Docket Number:	12-AFC-02C
Project Title:	Huntington Beach Energy Project - Compliance
TN #:	212797-1
Document Title:	California Coastal Commission's Report for Petition to Amend Application for Certification - Section 30413(d)
Description:	As approved by Coastal Commission, August 10, 2016
Filer:	Tom Luster
Organization:	California Coastal Commission
Submitter Role:	Public Agency
Submission Date:	8/15/2016 4:06:55 PM
Docketed Date:	8/15/2016

RE: Coastal Commission's § 30413(d) Report for the Petition to Amend Application for Certification #12-AFC-02C – proposed Huntington Beach Energy Project by AES Huntington Beach Energy, LLC ("AES")

**Coastal Commission Report
to
California CEC
on
Petition to Amend
Application for Certification 12-AFC-02C
– AES Huntington Beach Energy Project –**

**Reviewed pursuant to
Coastal Act Section 30413(d)**

Figure 2.1-2
General Arrangement/Site Plan
AES Amended Huntington Beach Energy Project
Huntington Beach, California

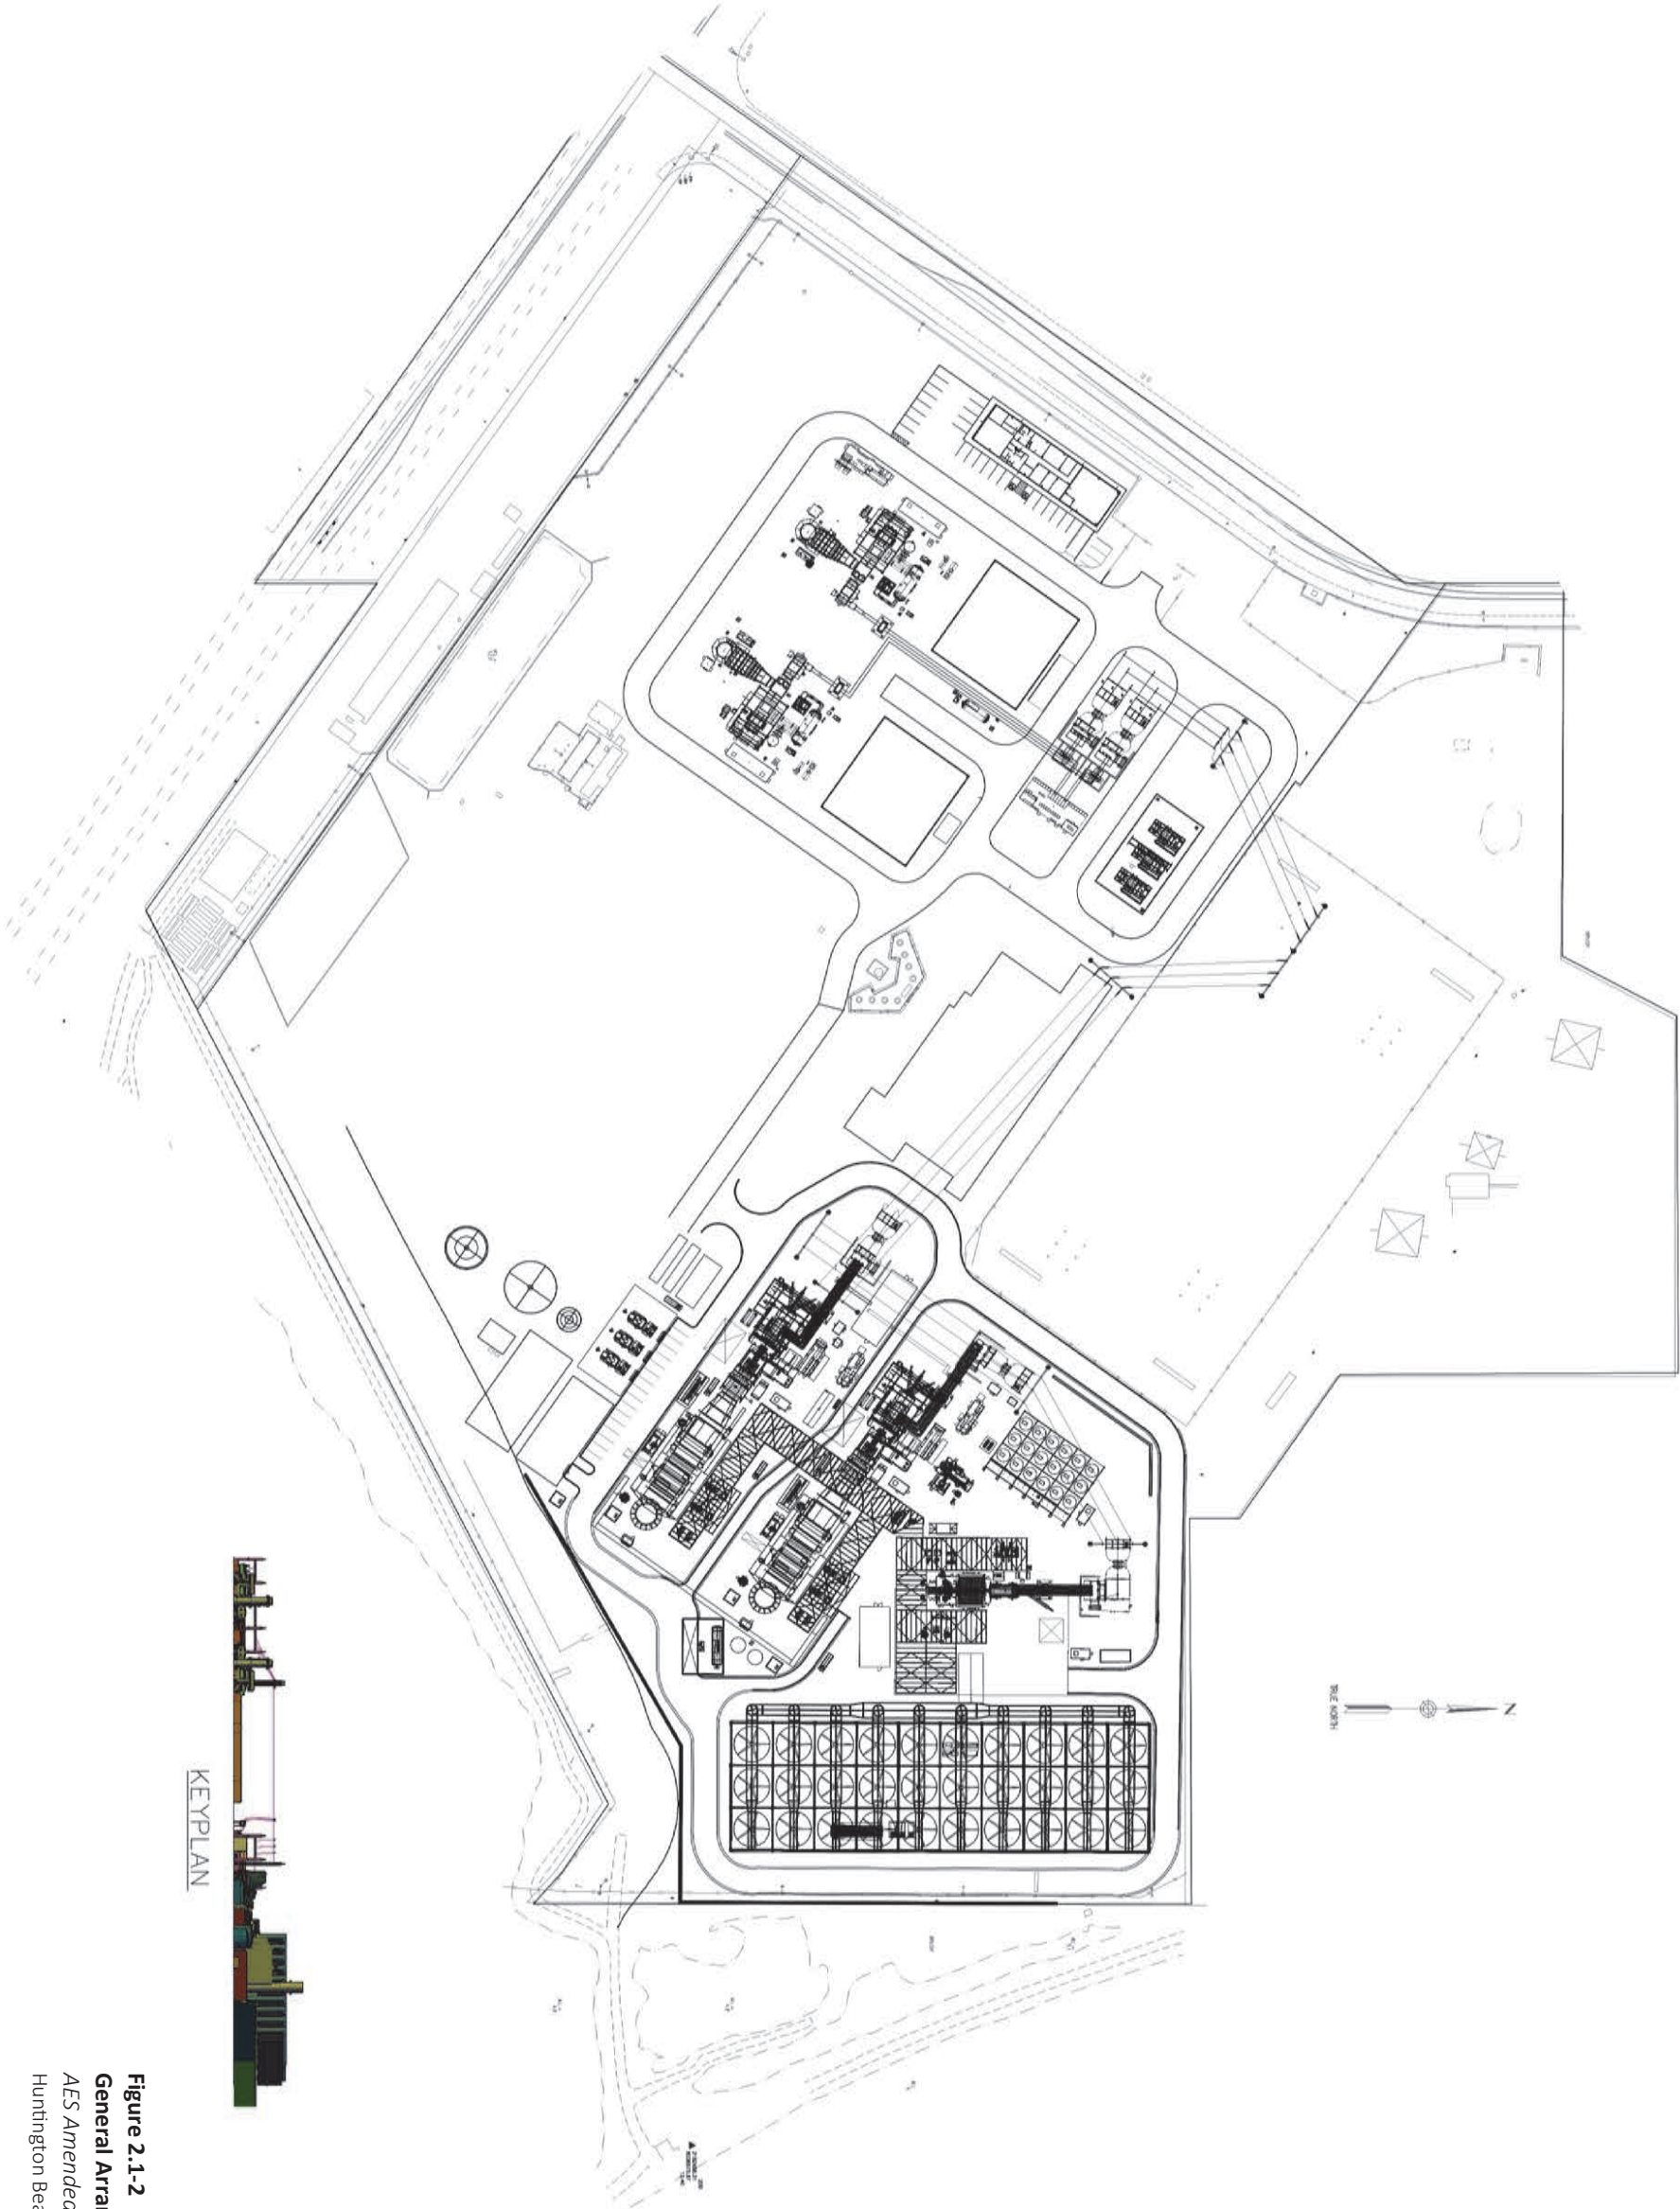
The currently proposed project would result in significantly increased adverse effects within the adjacent ESHA/wetland areas, as it would move major noise- and vibration-generating components closer to the sensitive species using these areas than the project as originally approved. Additionally, and as described below, studies and conclusions by wildlife agencies show that bird behavior is adversely affected by the sounds generated by construction such as that proposed by AES. The Coastal Commission is therefore recommending feasible provisions needed to avoid and reduce the proposed project's likely effects on these species in the adjacent ESHA/wetland habitat areas.

Limits on Allowable Noise Levels: The currently proposed project would bring major noise- and vibration-generating power plant components even closer to the sensitive species in the adjacent ESHA/wetland area than the previously proposed project and would create even more significant adverse effects. The current PSA, however, states only that the CEC’s previously approved Conditions BIO-1 through BIO-8 are adequate to prevent significant impacts to these species, though it does not provide an updated noise analysis to reflect the differences in the locations of the modified project’s noise generating activities and equipment. However, because the currently proposed project’s equipment and activities are largely the same as the previously proposed project, the Coastal Commission relies largely on the analysis provided in the prior CEC Staff Assessment.

Figure 5.2-2a. Sheet 01 of 02
National Wetlands Inventory
AES Amended Huntington Beach Energy Project
Huntington Beach, California

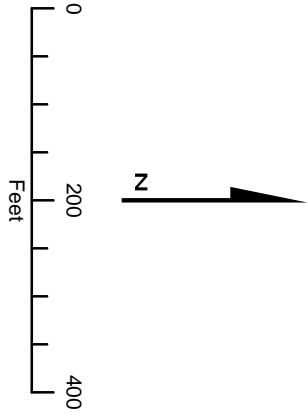
One area is described in AES's September 2015 Petition to Amend, which shows that the currently proposed project would fill and cause direct adverse effects to between one and two acres identified as wetlands by the U.S. Fish and Wildlife Service ("USFWS") pursuant to its National Wetland Inventory ("NWI") designation. Figure 5.2-2a in the Petition to Amend (see Exhibit 4) shows these mapped areas within and adjacent to the proposed project footprint. The Petition to Amend states (on page 5.2-2): "...the four fuel oil tank containment basins have been mapped as a palustrine system that has an unconsolidated bottom that is semi-permanently flooded and has been excavated (PUBFx); a portion of the southern-most containment basin is also mapped as a palustrine system that has an unconsolidated shore that is semipermanently flooded and has been excavated (PUSCx)..." However, AES's Petition goes on to say that while the USFWS designated these areas as wetlands, they are not "actual wetlands." AES states that it completed a wetland delineation for the project, though it has not been provided as part of the record before the CEC. AES references a document it provided during the previous AFC proceeding that describes a November 2012 site visit meant to show results of a wetland determination conducted pursuant to Coastal Commission guidelines (provided as Exhibit 5 of the Addendum). The document concludes that the area did not include wetlands; however, that assessment was not conducted consistent with Commission guidelines.

Based on results of the wetland determinations and delineation(s), the CEC should require AES to provide compensatory mitigation for any direct impacts in the form of wetland restoration at a 4:1 ratio at a nearby location. The Coastal Commission recommends this requirement be established through a new **BIO** condition, as provided as Exhibit 8 of this 30413(d) Report, that includes provisions for selecting a restoration site and developing a mitigation plan with adequate performance standards and monitoring measures to ensure any direct adverse effects to wetland areas are mitigated.
